CITY OF CODY
PLANNING, ZONING AND ADJUSTMENT BOARD
TUESDAY MAY 31, 2022
CITY HALL COUNCIL CHAMBERS @ 12:00 NOON

MEETING DATE:	MAY 31, 2022	TYPE OF ACTION NEEDED	
AGENDA ITEM:		P&Z BOARD APPROVAL:	X
SUBJECT:	SITE PLAN REVIEW: BAILEY ENTERPRISES (SINCLAIR) FUELING STATION AT 2019 BIG HORN AVE. SPR 2022-09	RECOMMENDATION TO COUNCIL:	
PREPARED BY:	TODD STOWELL, CITY PLANNER	DISCUSSION ONLY:

MEETING DATE:	MAY 31, 2022	TYPE OF ACTION NEEDED	
AGENDA ITEM:		P&Z BOARD APPROVAL:	X
SUBJECT:	SITE PLAN REVIEW: ROCKY MOUNTAIN GRANITE. SPR 2022-04	RECOMMENDATION TO COUNCIL:	
PREPARED BY:	TODD STOWELL, CITY PLANNER	DISCUSSION ONLY:

MEETING DATE:	MAY 31, 2022	TYPE OF ACTION NEEDED	
AGENDA ITEM:		P&Z BOARD APPROVAL:	X
SUBJECT:	DOWNTOWN ARCHITECTURAL REVIEW: EXTERIOR UPDATE TO 1021 14 TH STREET. SPR 2022-13	RECOMMENDATION TO COUNCIL:	
PREPARED BY:	TODD STOWELL, CITY PLANNER	DISCUSSION ONLY:

C2.0

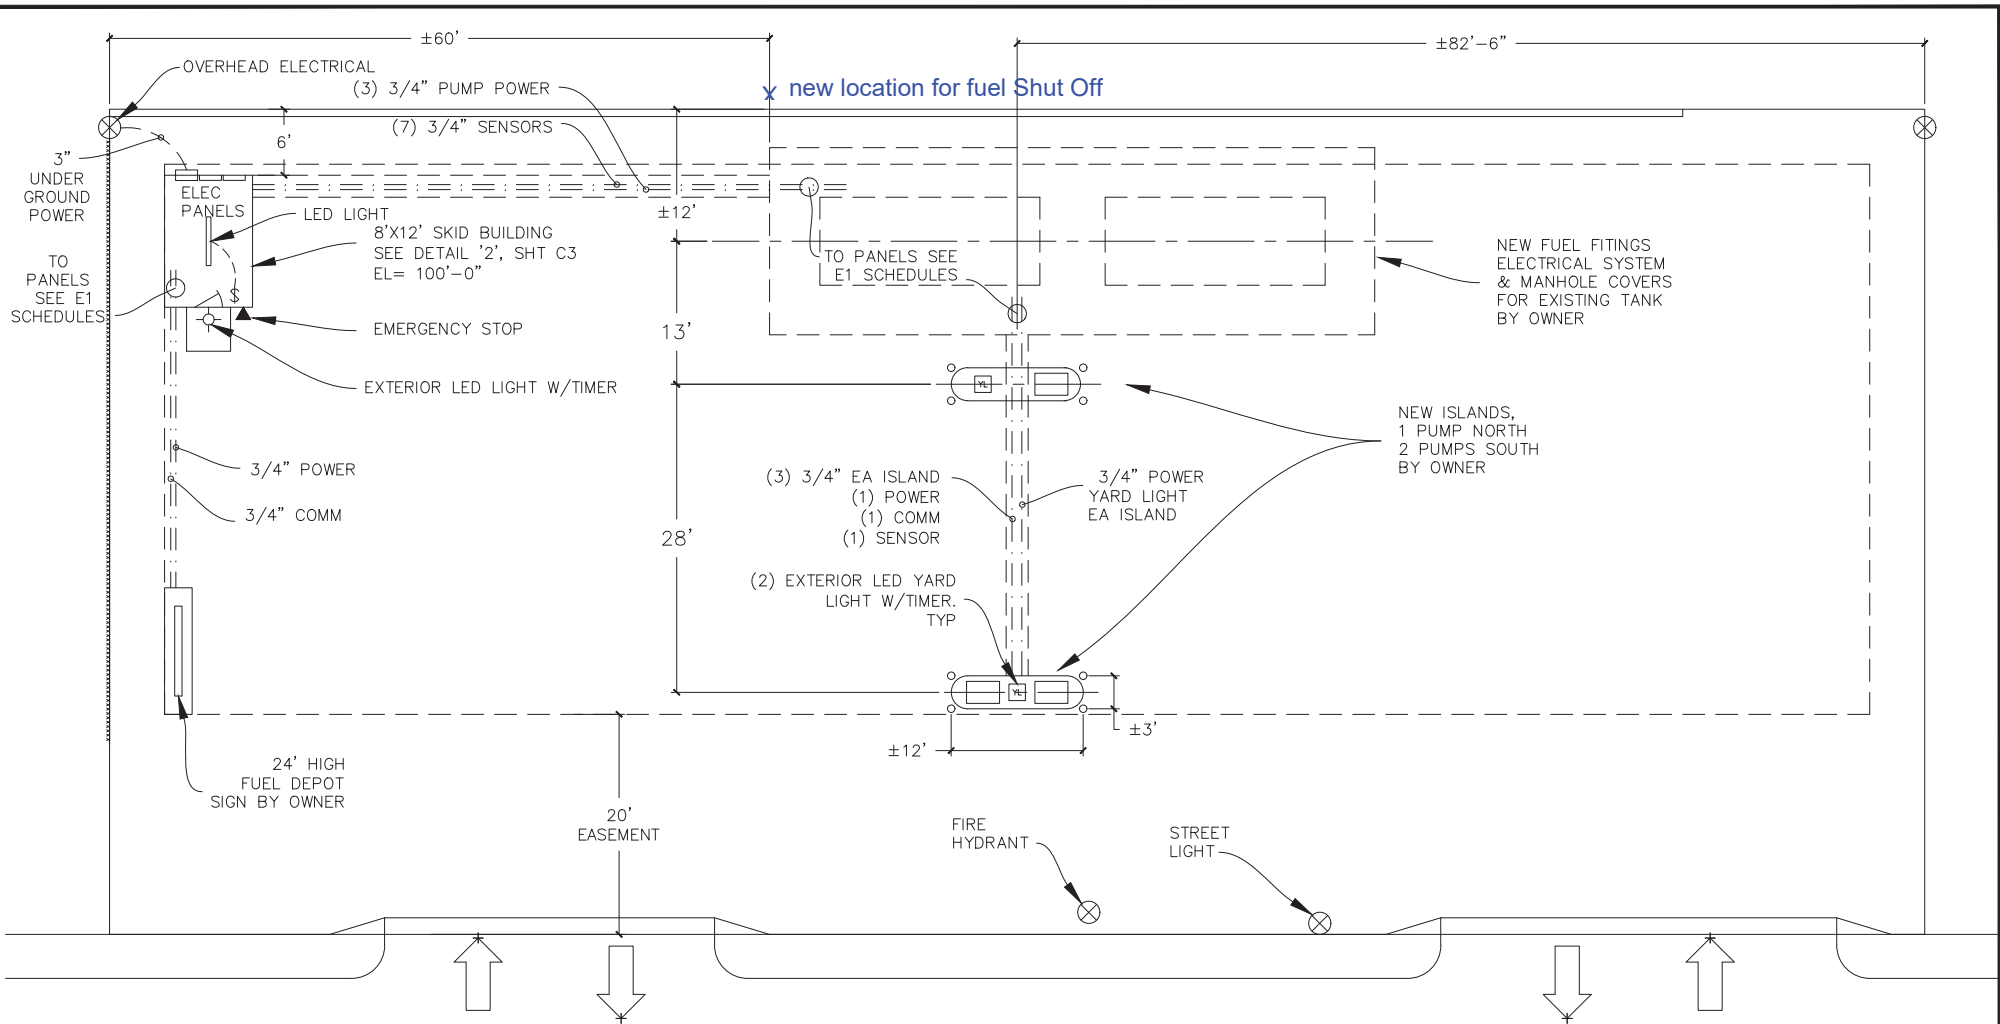
While the pump locations will be modified, the access drives along Big Horn Avenue are not changing.

Truck access has not been analyzed in detail, but it appears that there is sufficient room for delivery fuel trucks to maneuver within the site and not block the driveway to the neighbor to the north, or extend off the site onto Big Horn Avenue.

A fire hydrant is on the property. Due to the shifting of the gas pump location closer to the hydrant, the fire marshal and City water division have requested that the hydrant be protected with bollards.

A dumpster location is not specified. To minimize visual impacts, staff recommends that the dumpster be in the northwest portion of the site. If that does not work for some reason, coordinate further with the City planner and Sanitation department.

- 1) The landscaping on the northern portion of the property is to be maintained, unless a new landscaping plan is provided and approved, which complies with the entry corridor overlay requirements.

- c) Equipment building lighting, if provided, is to be full cut-off in design, and/or low intensity (18-watt LED or less).
- 3) Provide bollards to protect the fire hydrant, as determined by the fire marshal and water department.

- 5) The dumpster shall be towards the back of the developed site.
- 6) The project shall otherwise comply with the approved site plan and applicable building, fire, electrical, and zoning codes.

C 2.1

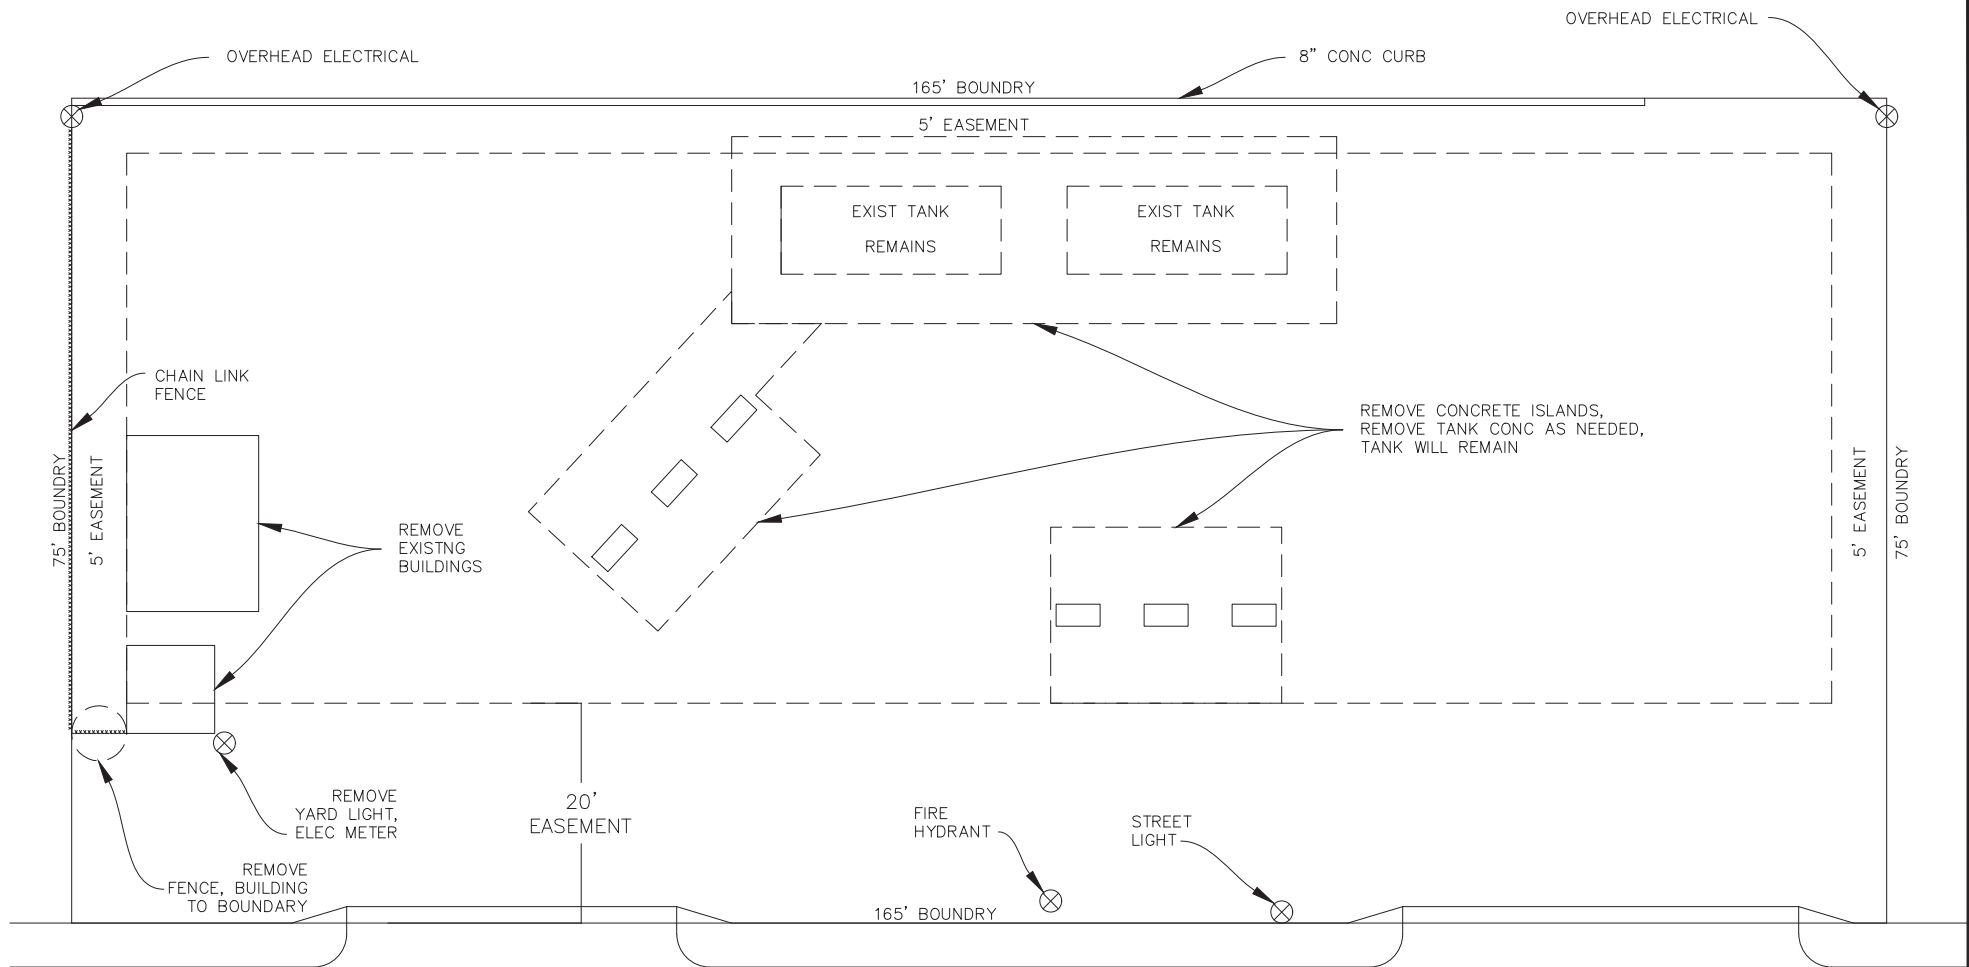
fixtures, one on each island. At the time of this staff report, I am still awaiting verification on the number and height of fixtures. Full details are attached. Here is the photometric for a single light.

It appears that one light fixture at each island would be sufficient. With one light at each island, lighting levels at the pumps would appear to be around 10-15 footcandles or more (brochure photometric doesn't provide enough detail for a reliable number). Some light spillover would occur onto Big Horn Avenue (about 3 footcandles at the curb line) but that does not seem excessive. At the neighboring properties, it would be very minimal (approx. 0.5 footcandle).

In an email, the applicant stated that an additional light may be added to the pole to shine towards the equipment building (think spotlight). That is not a preferred method, as it creases a glare situation for the residence to the north. A simple porch light on the equipment building itself is the preferred method. The porch light should be either low intensity (18-watt LED or less), and/or full cut-off-in style.

To minimize blue light impacts, the 4,000K color option should be used, rather than the 5,000K option.

- 2) Exterior lighting shall comply with the following:
 - a) Color temperature of 4,000K or less;
 - b) Island lighting is limited to one fixture on each of the two poles, mounted flat, and of the lighting pattern and intensity proposed, or less. Pole height is limited to 20 feet for the fixtures proposed.

SINCLAIR R70 SIGN

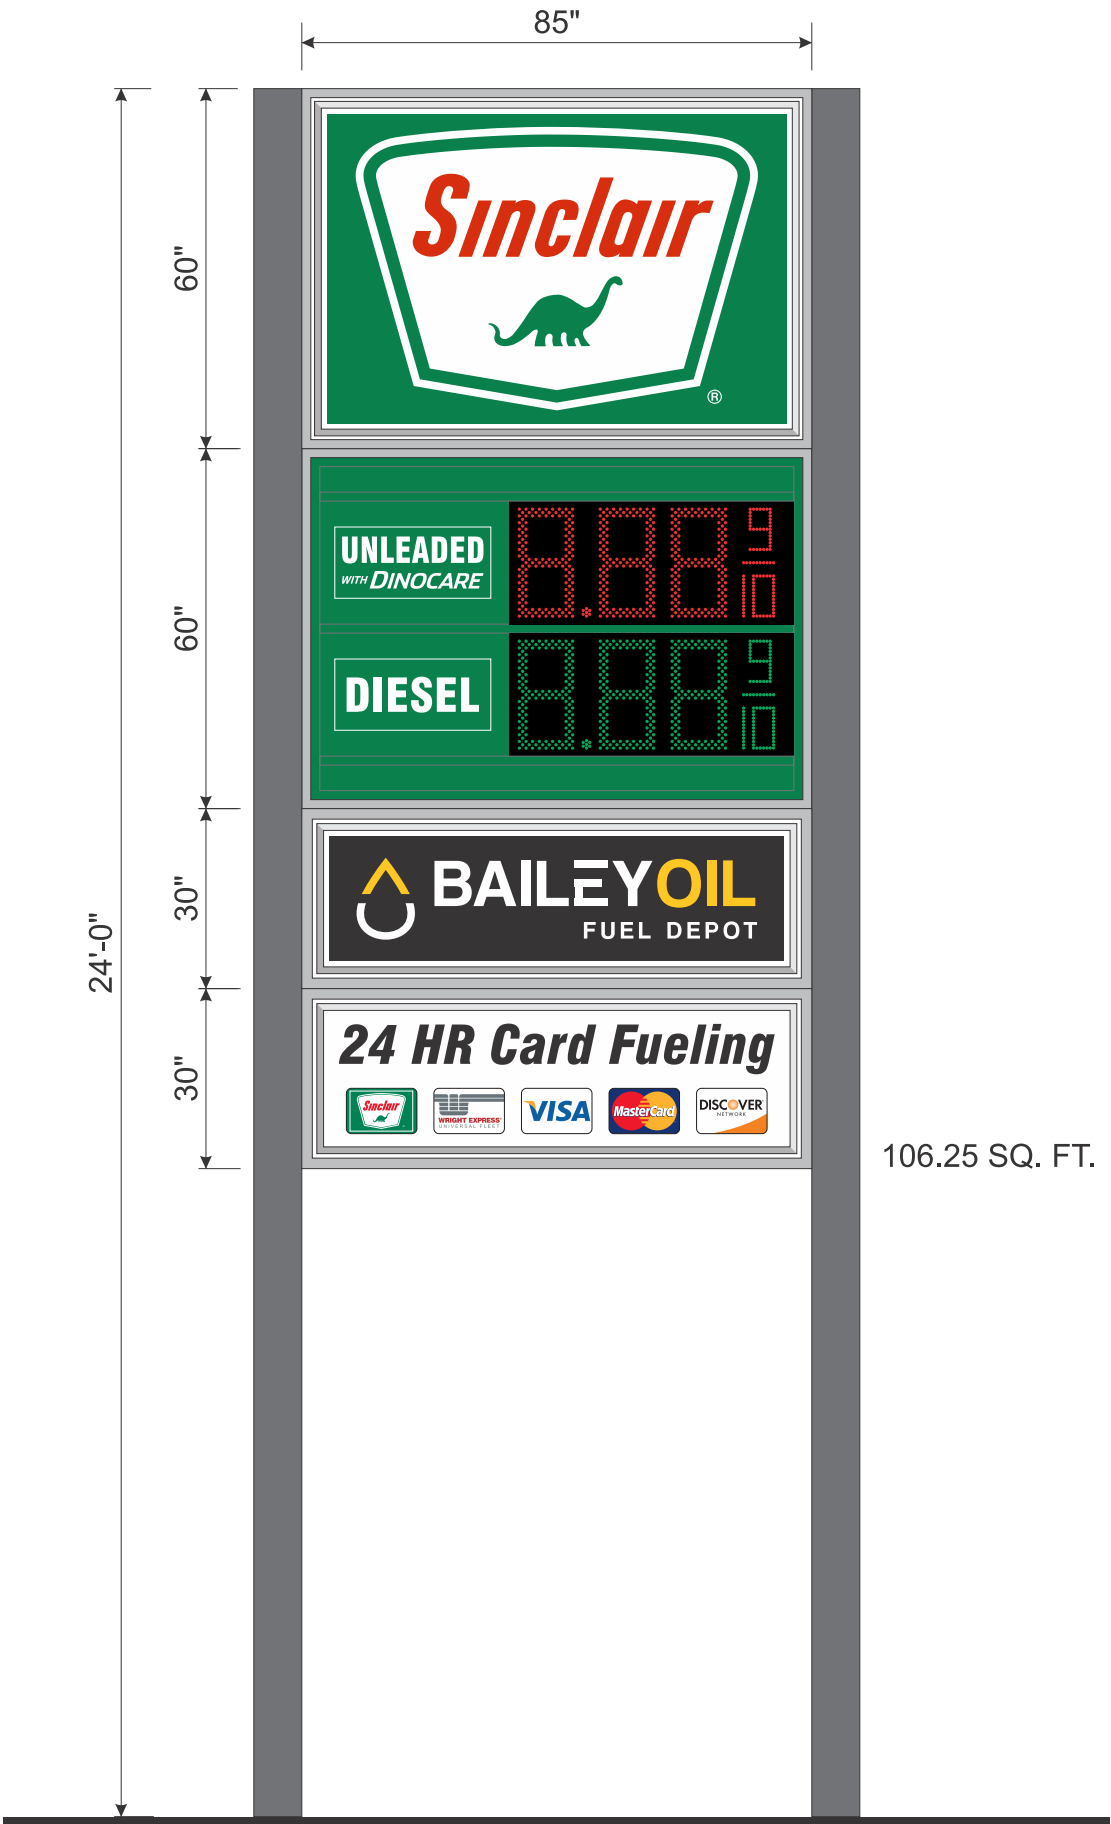
The proposed freestanding sign would be approximately 24 feet in total height, where 25 feet is the maximum allowed. The sign cabinets measure 7'1" wide and 15 feet tall, for a total of 106.25 square feet, which is within the amount allowed. The sign (and associated footing) would be located in the southwest portion of the property, outside of the utility easements. The LED components would have auto-dimming, to comply with the city requirements for electronic message boards.

Two existing faded out sign panels are located along the east boundary of this property. As the sign code requires 200 feet between freestanding signs on the same property, and the property is only 165 feet wide, those existing signs and mounting structure will need to go. The applicant has indicated that it will be removed.

- 4) The new freestanding sign is not authorized to be installed until the existing signs and sign structure on the east side of the property are removed.

2 SOUTH ELEVATION

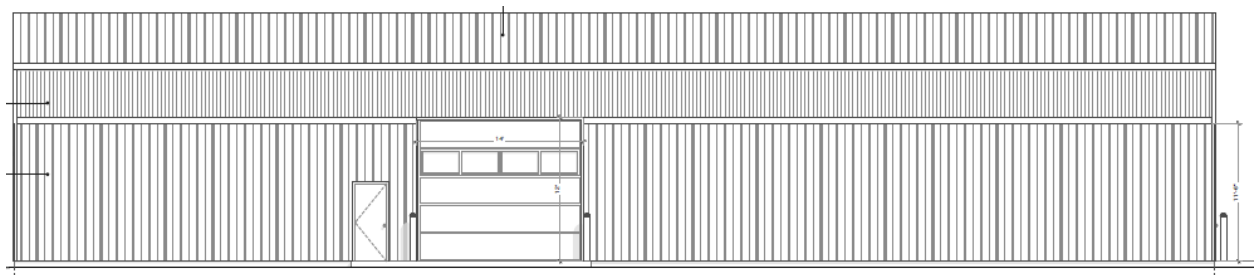
The variety of materials, textures, and colors, as well as the proportionately-scaled entryway enhance the building greatly. The result is an architectural similarity to several other newer and renovated buildings in the east end of the Big Horn Avenue corridor. For an industrial building, the architectural enhancements are much appreciated and demonstrate that with enough thought and planning, the result can be significant, with relatively minimal additional cost that clearly adds value.

PROJECT:
ROCKY MOUNTAIN GRANITE
TITLE:
PROPOSED SITE PLAN

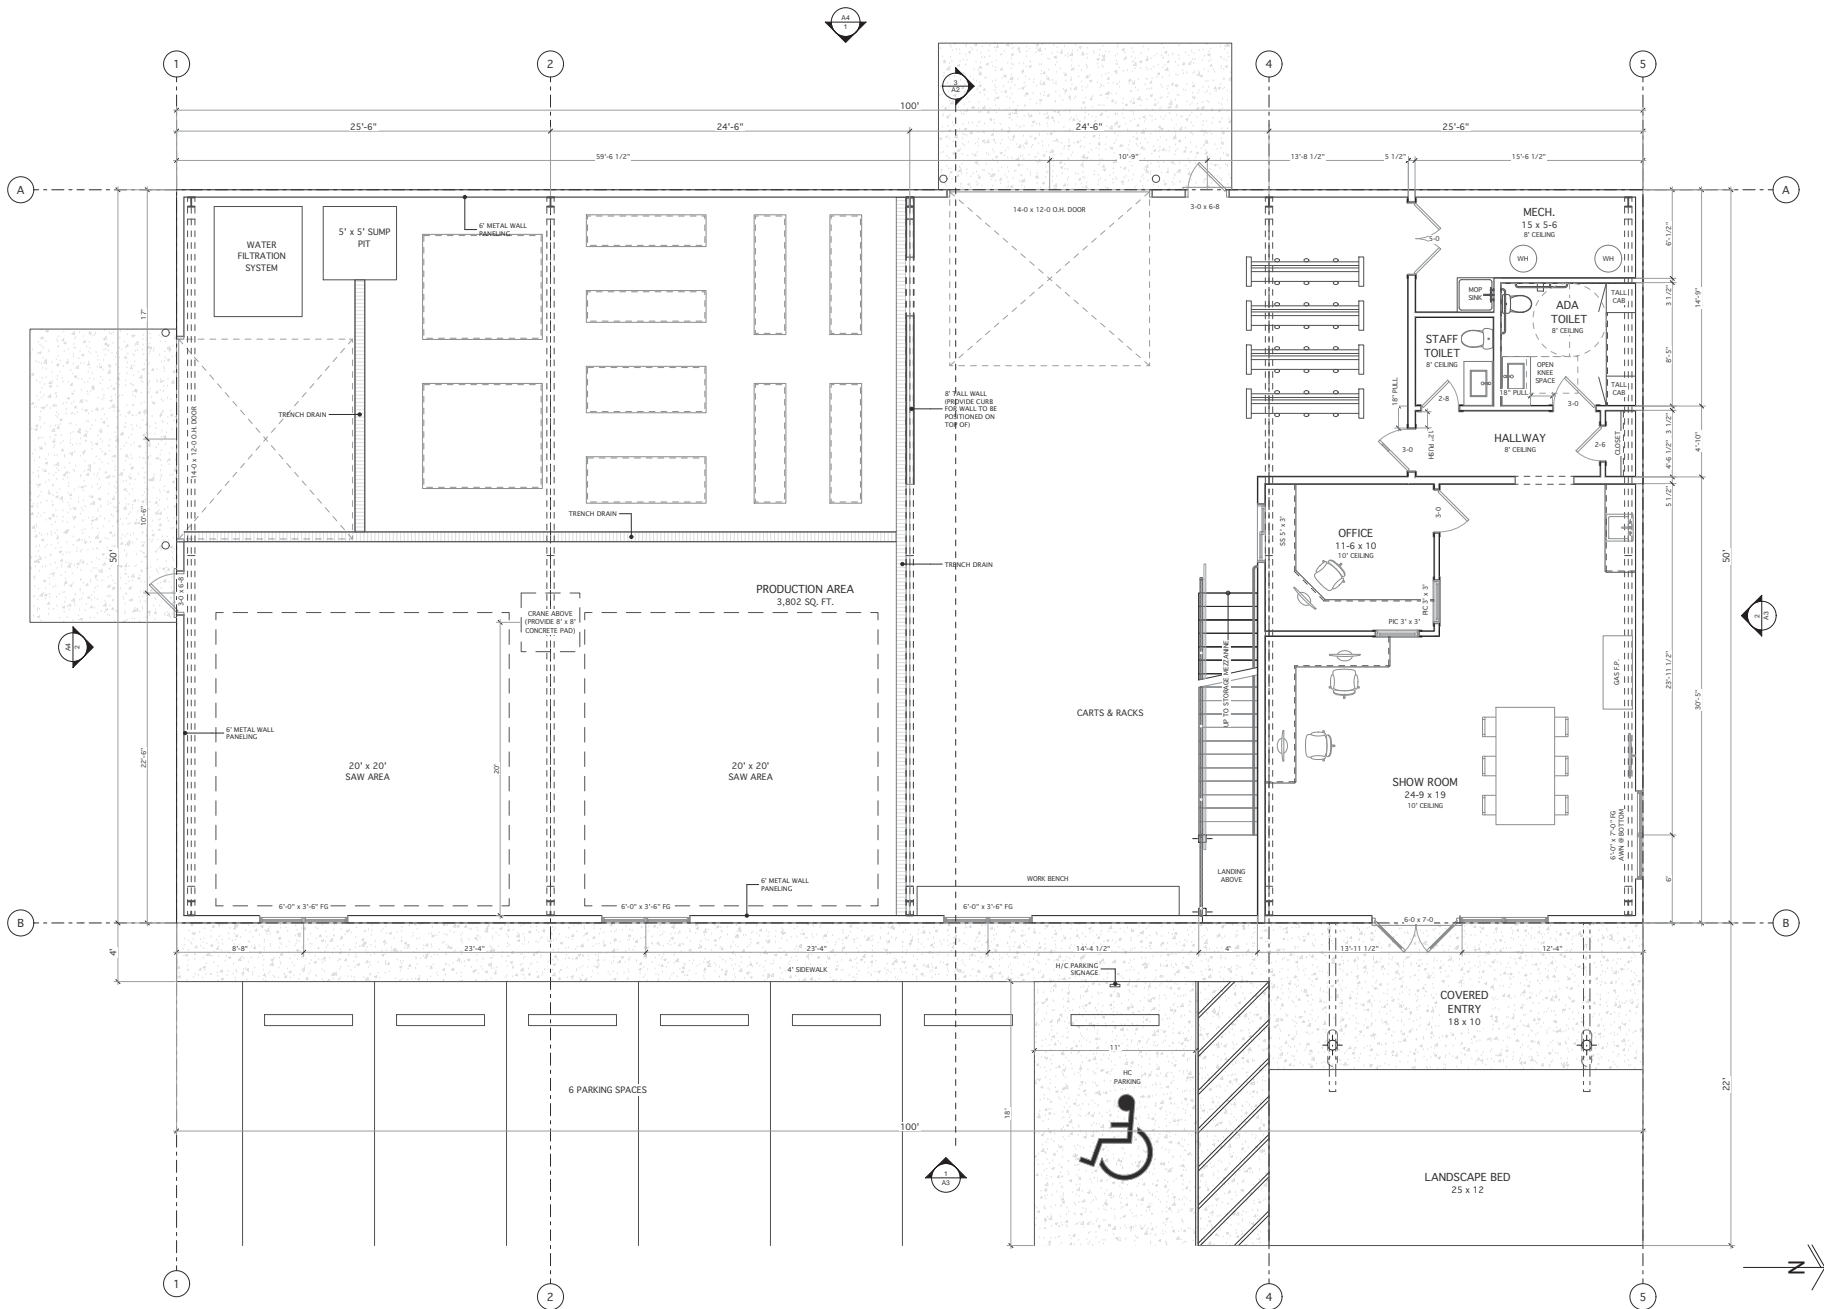
The proposed access layout shown on the site plan by Engineering Associates is acceptable to public works and the parking lot layout meets applicable standards, with the following minor modifications.

The minimum width for gravel parking is 10 feet by 20 feet (18 feet from back of parking block). The parking spaces are drawn at 9 feet wide and 18 feet (16 feet from back of parking block). All other dimensional requirements for the parking lot are met. The gravel parking spaces are delineated by the spacing of the parking blocks—there is no striping.

As the parking lot is proposed to be level with the building sidewalk, no ADA ramp is needed. The plans comply with the maximum 2% slope requirement and hard surfacing for the ADA parking space and unloading aisle. However, there is not detail regarding how the sidewalk/entry concrete will be sloped to make up the 7-inch difference between the sidewalk and the floor elevation of the building at the front doorway. Being a commercial building, the landing area at the front door must meet the elevation of the floor-no step is allowed. Additional information is needed.

The site plan shows seven parking spaces, when the City parking code recommends eight. The applicant is confident that based on her current facility, the seven spaces will be adequate. The Board can accept reliable data in determining the number of spaces required. If eight spaces are needed, it would simply be a matter of putting down one more parking block at the south end of the row.

The grading and stormwater plan has been prepared by a professional engineer and meets minimum requirements. In brief, much of the site will be graded to flow naturally towards the south end of the property, where it will be captured by a very broad and shallow swale. The grading is shown on the site plan, and the storm water report is attached.

The connection locations for sewer, water, and natural gas are shown appropriately on the site plan. For the water connection, there will need to be a tap made to the existing 4" line that is stubbed into the property. Coordinate with Public Works. Applicable utility fees will need to be paid with the building permit.

The dumpster location is not indicated on the engineer's site plan. In conversation with the owner, it sounds like placing the dumpster just off the south end of the building would be acceptable. The back corner would be preferred for aesthetic reasons.

1. Provide additional detail on the walking surface between the ADA parking space and the front entryway, to demonstrate compliance with applicable building code and ADA standards. An acceptable plan must be provided before the building permit is issued.
2. Exterior lighting shall be full cutoff in style and not have a higher color temperature than 4,000 Kelvin.
3. Management of the exterior lighting shall occur as discussed with the planning and zoning board (timer for wall packs?).
4. The number of parking spaces must be at least _____, and the gravel spaces must be at least 10 feet wide, as delineated by parking blocks spaced 10 feet on center.

5. Coordinate the transformer location with the electric division. Provide additional easement if necessary for the transformer location.
6. Pay the applicable utility connection fees with the building permit fee. Coordinate installation with Public Works.
7. Upon completion, the storm water facilities must be inspected and certified by the applicant's engineer that they were completed according to the approved plans or equivalent, prior to building occupancy.
8. The project must otherwise comply with the project description, as described in the application and at the Planning and Zoning Board meeting. A building permit must be obtained within three years or this authorization will expire.
